GUIDANCE CHANGES NOTICE No.2

October 2022

GUIDANCE FOR CODE AND CONVENTION INTERPRETATIONS

Biro Klasifikasi Indonesia

Fig. 1

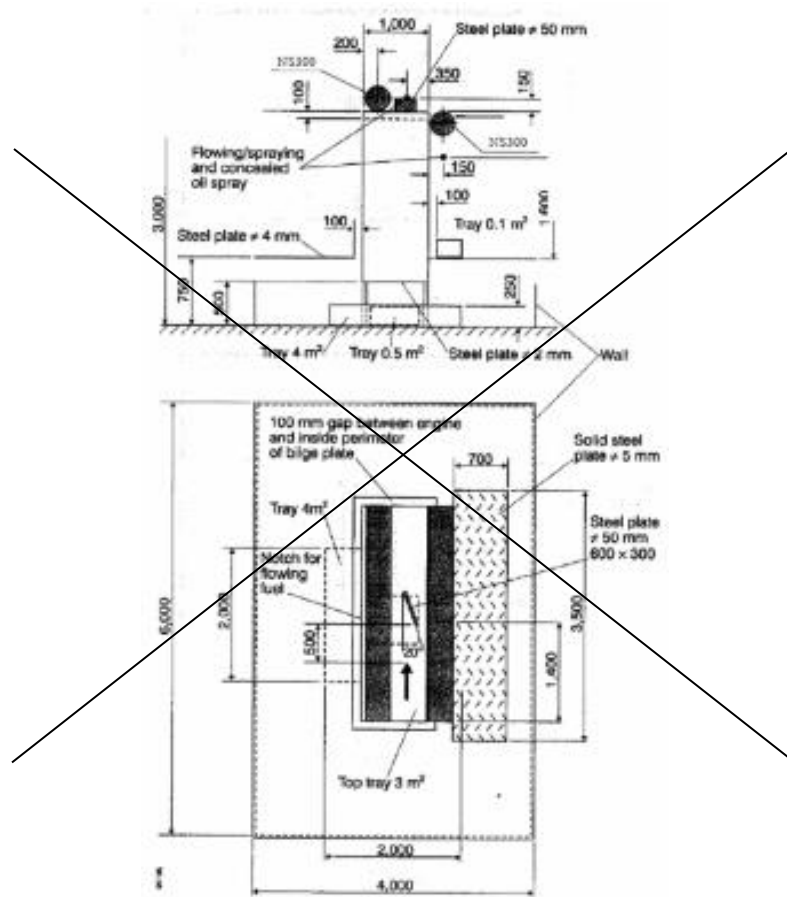
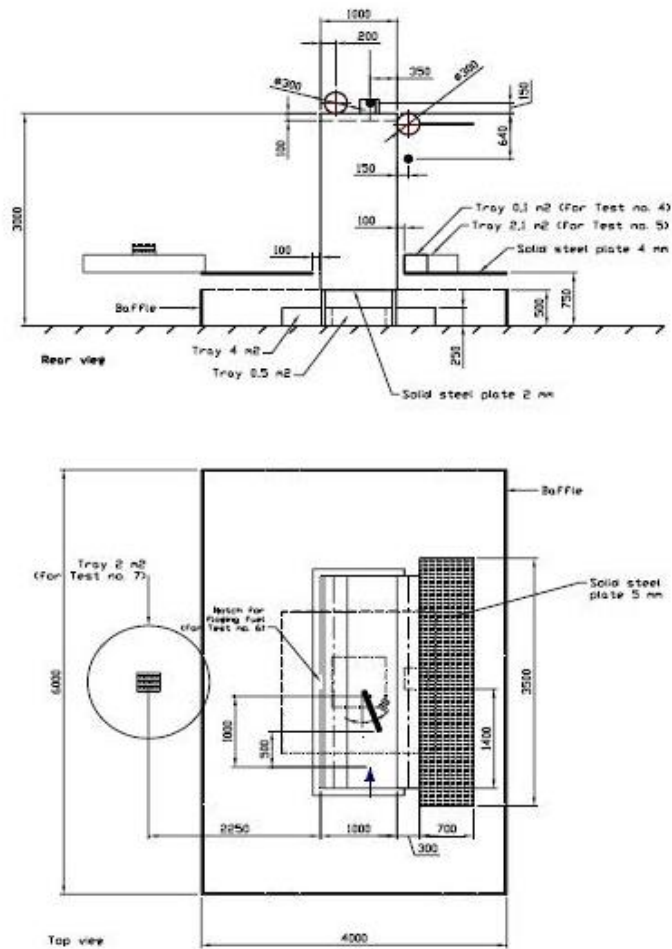
It has been recognized that this cannot be achieved for the 3 m² top tray as the total height of this particular tray is only 100 mm.

The freeboard requirement of 150 mm applies consequently only to the 0,1 m², 0,5 m², 2,1 m² and 4 m² tray (see IMO MSC/Circ.1165, Appendix B, MSC.1/Circ.1237, Annex, Figure 1).

Freeboard in the 3 m² top tray measured from heptane level (which is same as top of notch) to the top of this tray shall be 50 mm.
